Access Compliance Report

Public Rights-of-Way

Intersection ID: 51243	Main Street: NORTHCREST SHOPPING CENTER DR	Cross Street: W W T HARRIS BV	Location: SW
ADA ID: 892C6E973A73	Ramp Type: PerpDiag	Initial Pass/Fail: Fail	Overall Compliance: No
		Severity Score: 22.5

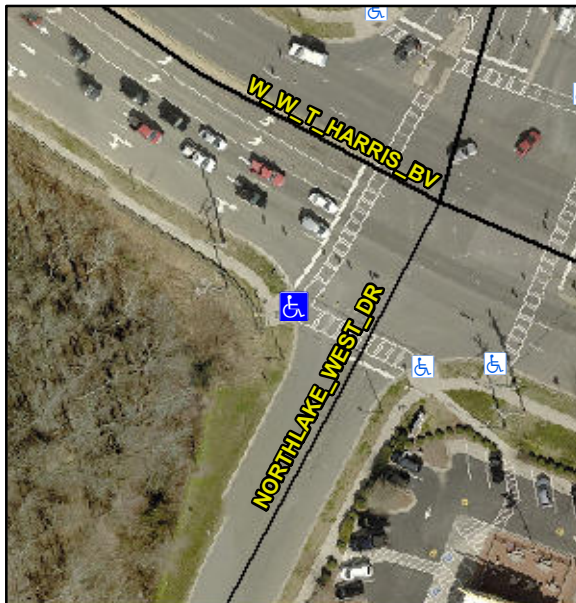
Not Found, R304.5.1, R304.2.2, R304.5.3

Compliance	Description	Data	Compliance	Description	Data
N/A	Ramp Length (in)	94.0	No	Ramp Slope (%)	8.4
No	Ramp Width (in)	46.0	No	Ramp XSlope (%)	2.5
N/A	Flare Type LT	N/A	N/A	Flare Type RT	N/A
N/A	Flare Slope LT (%)	N/A	N/A	Flare Slope RT (%)	N/A
N/A	Flare Traversable LT?	N/A	N/A	Flare Traversable RT?	N/A
N/A	Landing Length (in)	N/A	N/A	DWS Provided?	N/A
N/A	Landing Width (in)	N/A	N/A	DWS Contrast?	N/A
N/A	Landing Slope (%)	N/A	N/A	DWS Length (in)	N/A
N/A	Landing X Slope (%)	N/A	N/A	DWS Full Width?	N/A
N/A	Landing Curb? (Y/N)	N/A	N/A	DWS Offset (in)	N/A
N/A	Shared Landing?	N/A			
N/A	Gutter Ponding?	N/A	N/A	Gutter Slope (%)	N/A
N/A	Gutter Lip Ht (in)	N/A	N/A	Gutter X Slope (%)	N/A
N/A	Painted X Walk1?	Yes	N/A	Painted X Walk2?	Yes
	X Walk 1 Direction	To SE		X Walk 2 Direction	To NE
N/A	X Walk 1 Width (in)	108.0	N/A	X Walk 2 Width (in)	75.0
	X Walk 1 Slope (%)	1.4		X Walk 2 Slope (%)	0.8
	X Walk 1 X Slope (%)	0.8		X Walk 2 X Slope (%)	1.3

Remove & Replace Curb Ramp With Two New Directional Ramps or Equivalent.
